STAFF REPORT

TO: City Council
FROM: Ken Roberts, Planning Director
AGENDA ITEM: **Zoning Map Amendment and Preliminary Plat and Preliminary Planned Unit Development (PUD) Plans – Springs Apartments**
REVIEWED BY: Ben Prchal, City Planner
Jack Griffin, City Engineer

Sheet No. **Revision**
C3.01

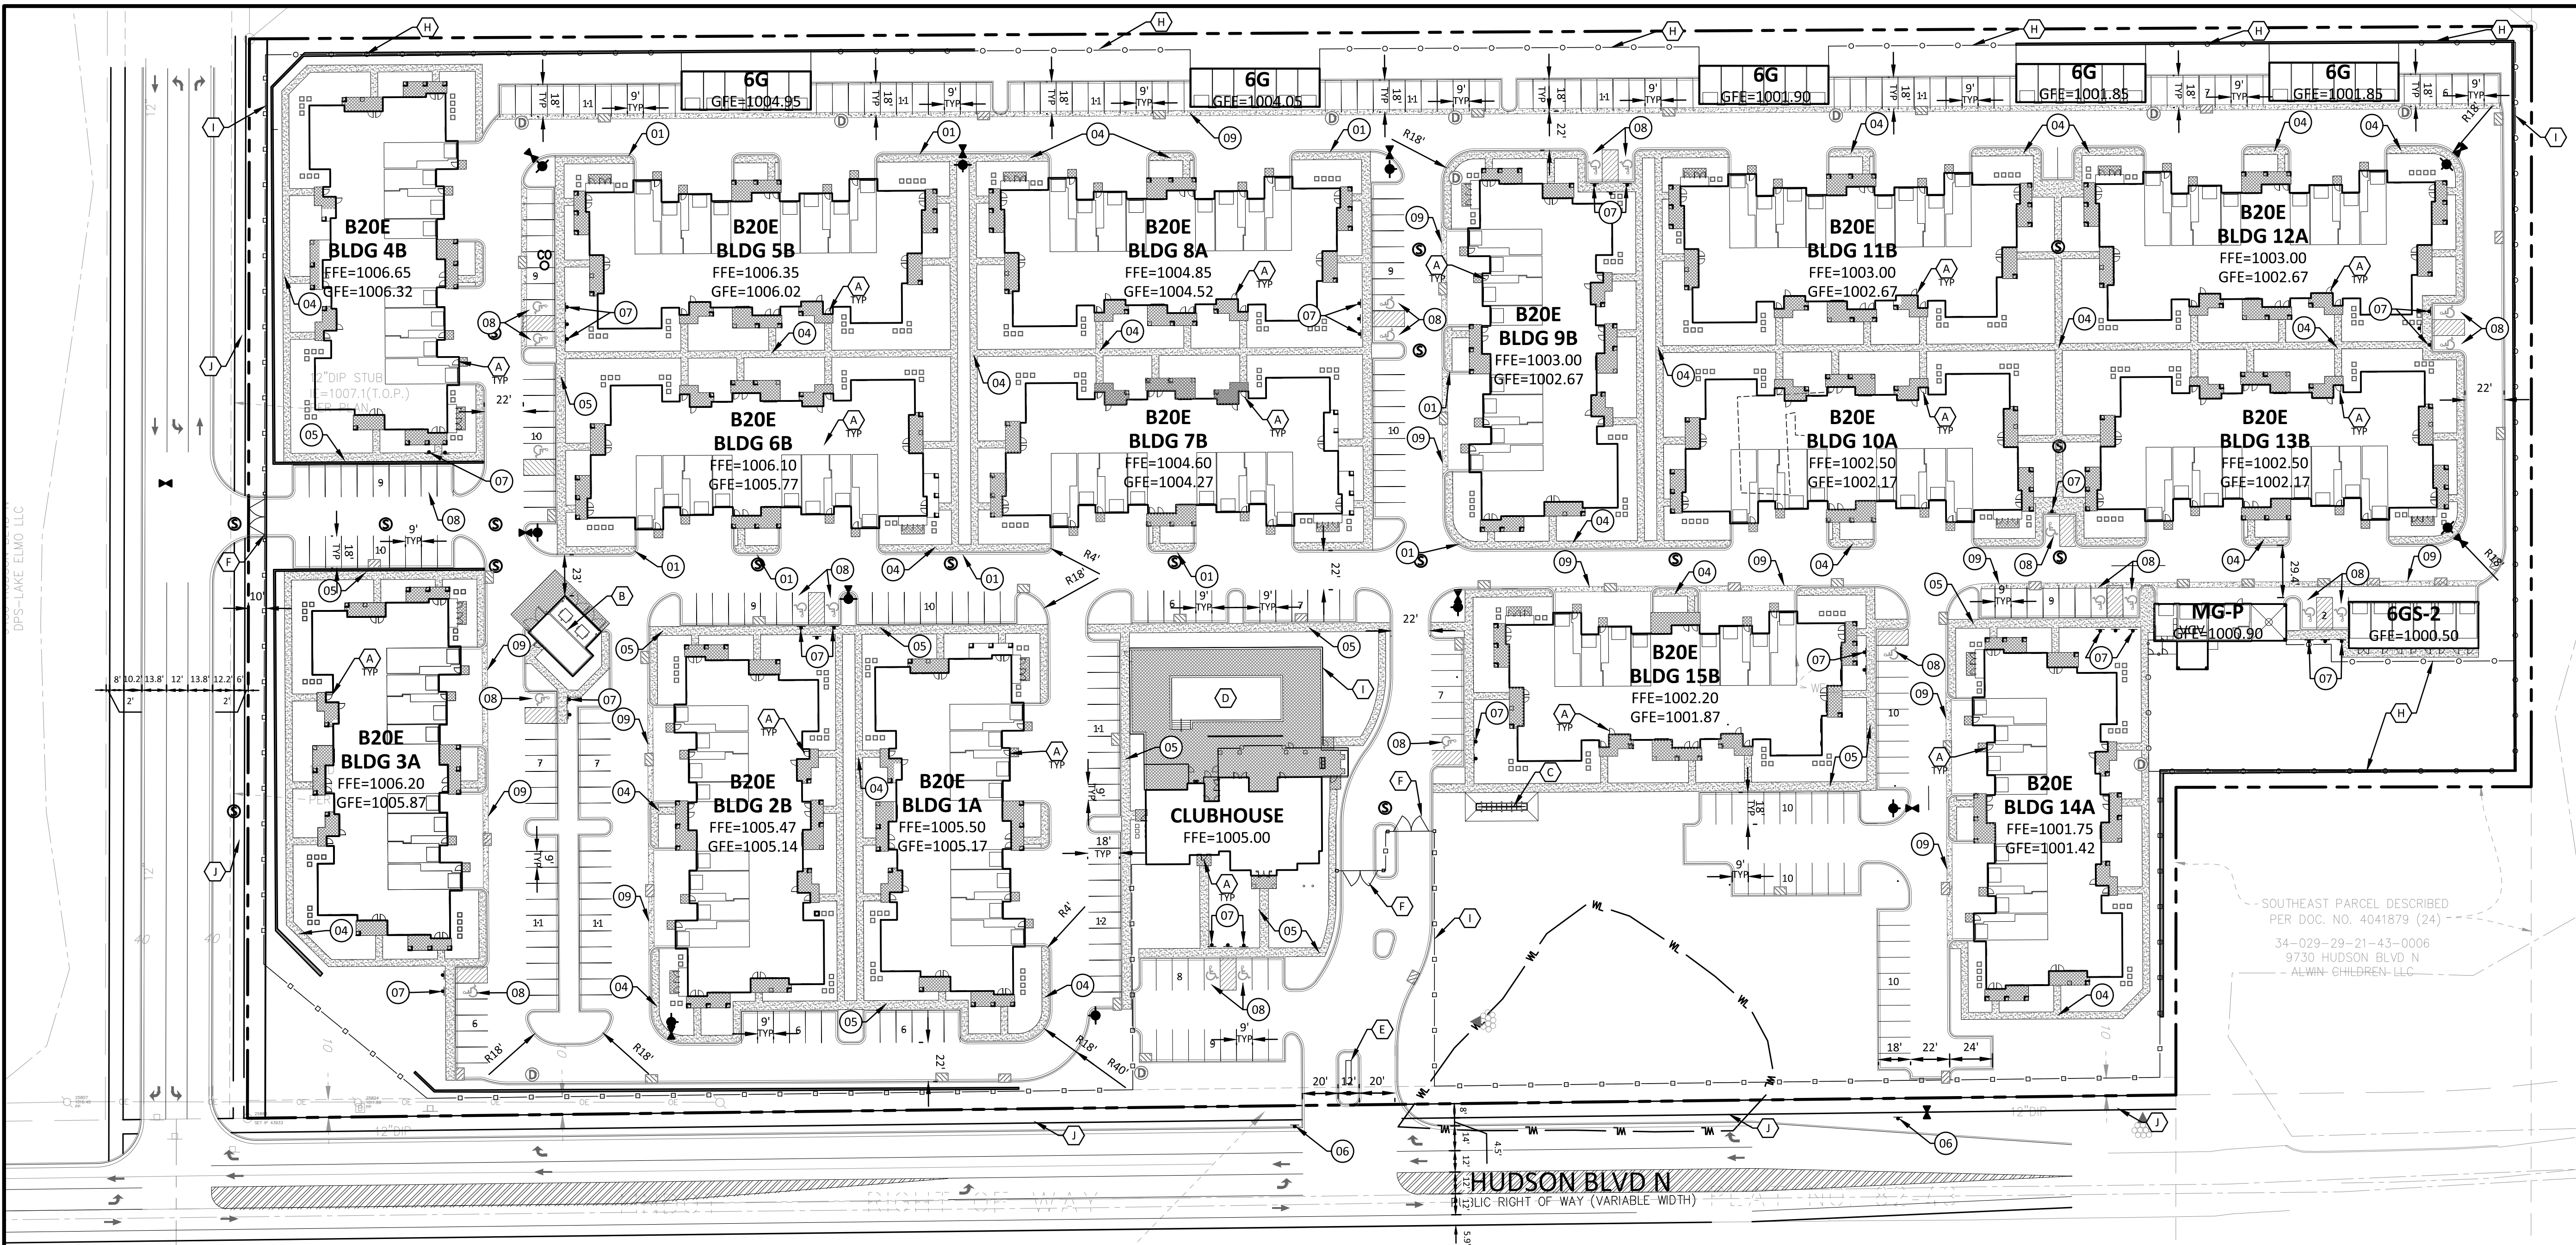
- Sheet C3.01 Revised Site Plan. A revised site plan was received that among other changes, relocates the secondary (emergency) access to Julia Avenue. This new location is a requirement for City approval. Design details for the emergency access will need to be further reviewed once the remaining grading and utility plan revisions are received.

- Sheet C3.01 Revised Site Plan. The typical section dimensions shown for Hudson Boulevard are not consistent with the Hudson Boulevard design standards and appear to create a centerline shift to the south. This design/alignment may not be an approvable design. Information provided is incomplete to facilitate a full review. The Final Plat application must include a revised Hudson Boulevard design that is consistent with the City design standards.

- Sheet C3.01 Revised Site Plan. Perimeter Fence. A perimeter decorative fence is shown around most of the proposed site and often encroaches the easement or right-of-way by 1-2 feet. The fence locations must be revised to reside 1-foot inside the property lines or easement lines as applicable.

- Sheet C3.01 Revised Site Plan. Retaining walls are shown around the perimeters for most of the site. The retaining wall locations must be revised to reside on or inside of the property lines or easements as measured at the wall footing to preserve the full use of the easement or right-of-way.

Sheet No. Revision
C5.02

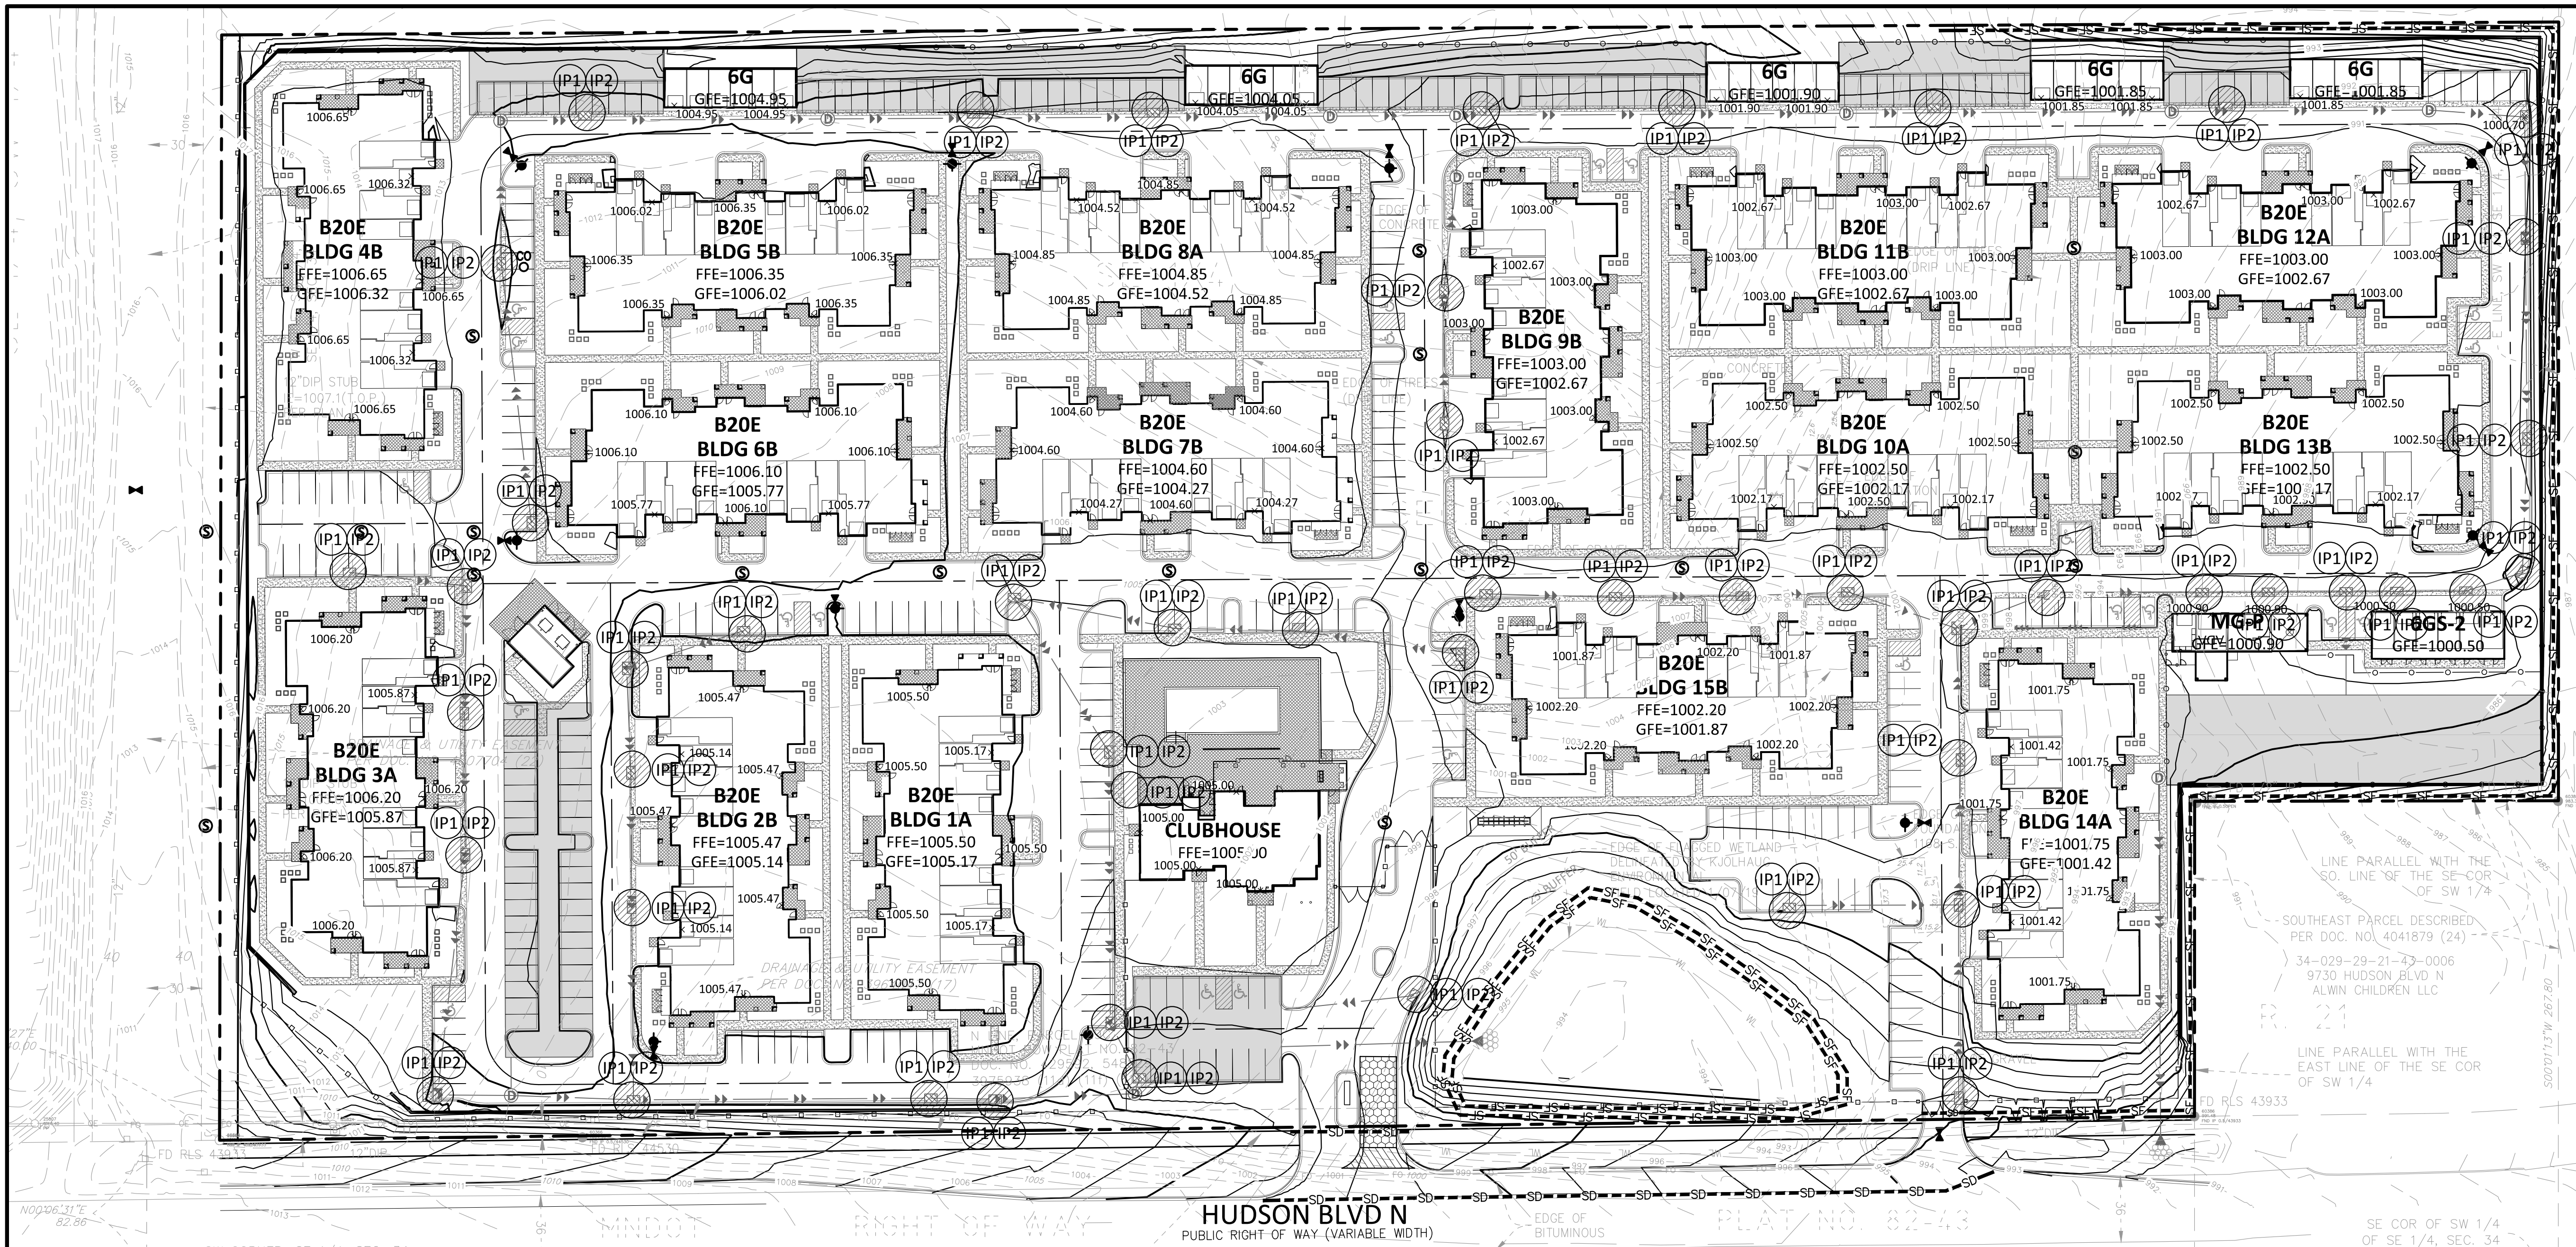
- Sheets C5.01 – C5.03 Erosion Control Plans. The erosion control plans must be revised to be consistent with the City of Lake Elmo Design Standards manual including use of City Standard erosion control plan notes and details. Conflicting or redundant plan notes and details should be removed from the plans.

Sheet No. Revision C6.02

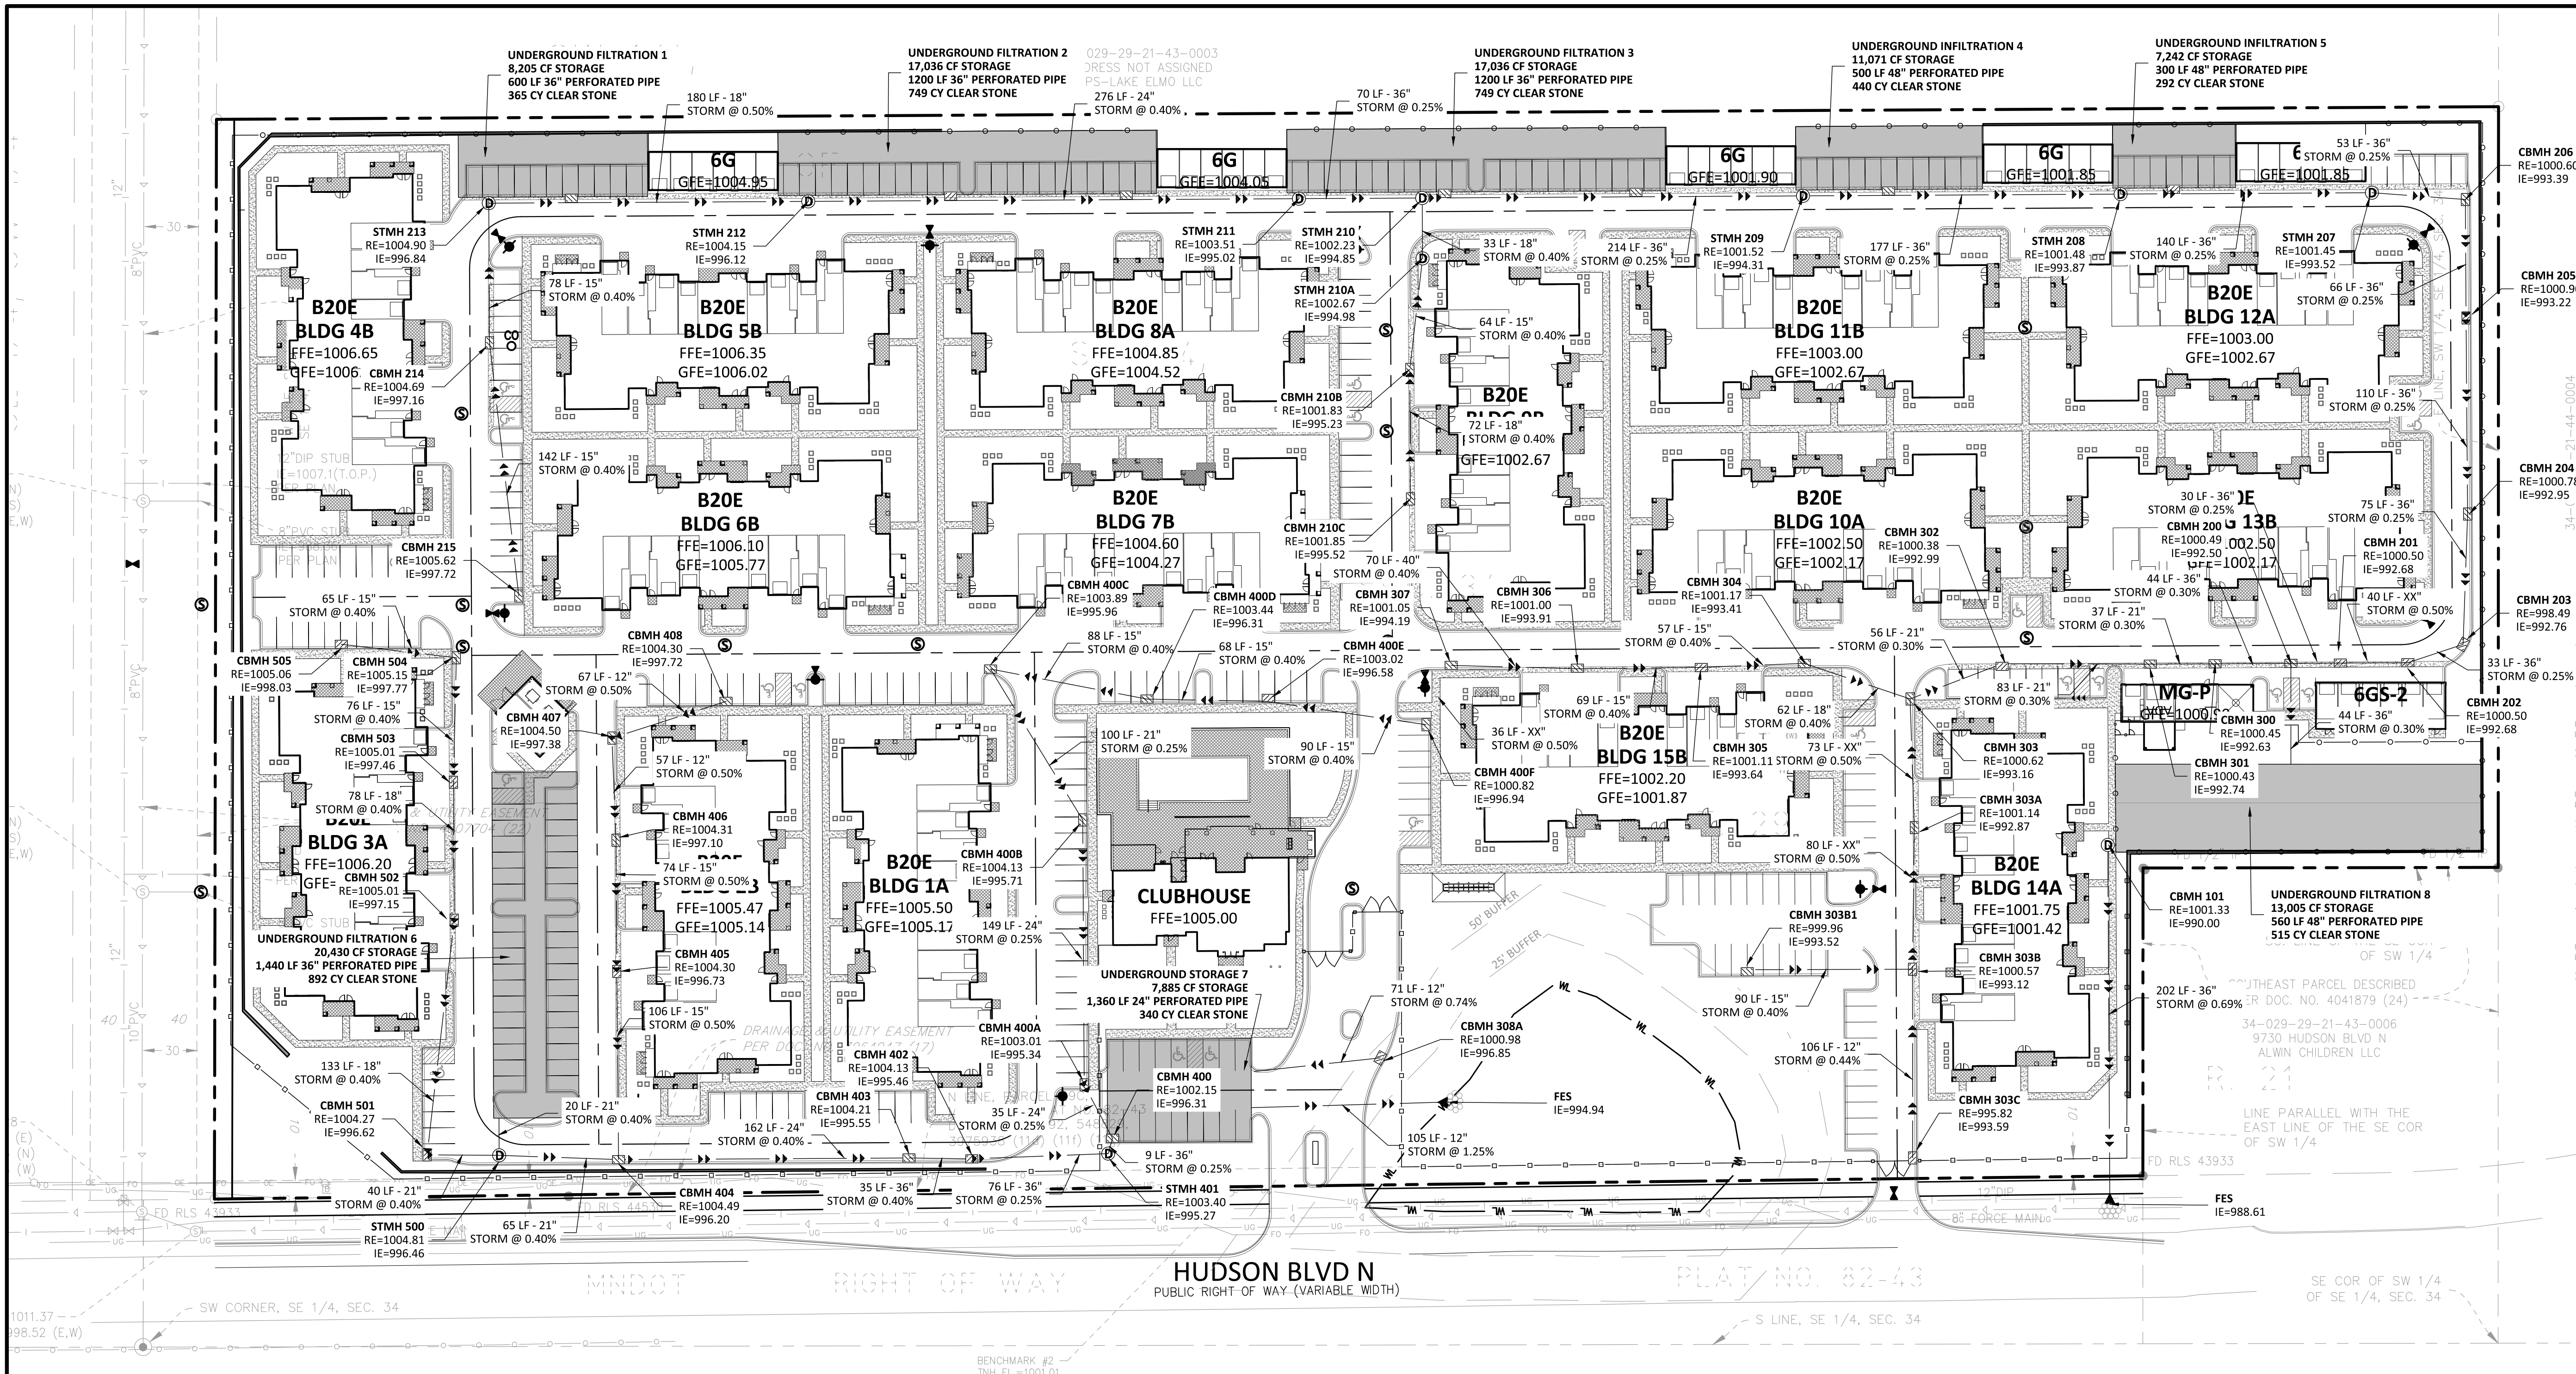
- Sheet C6.02. Storm Sewer Plan. The storm sewer plan is incomplete.
 - The storm sewer improvements along Hudson Boulevard and Julia Avenue must be incorporated into the construction plans for City review.
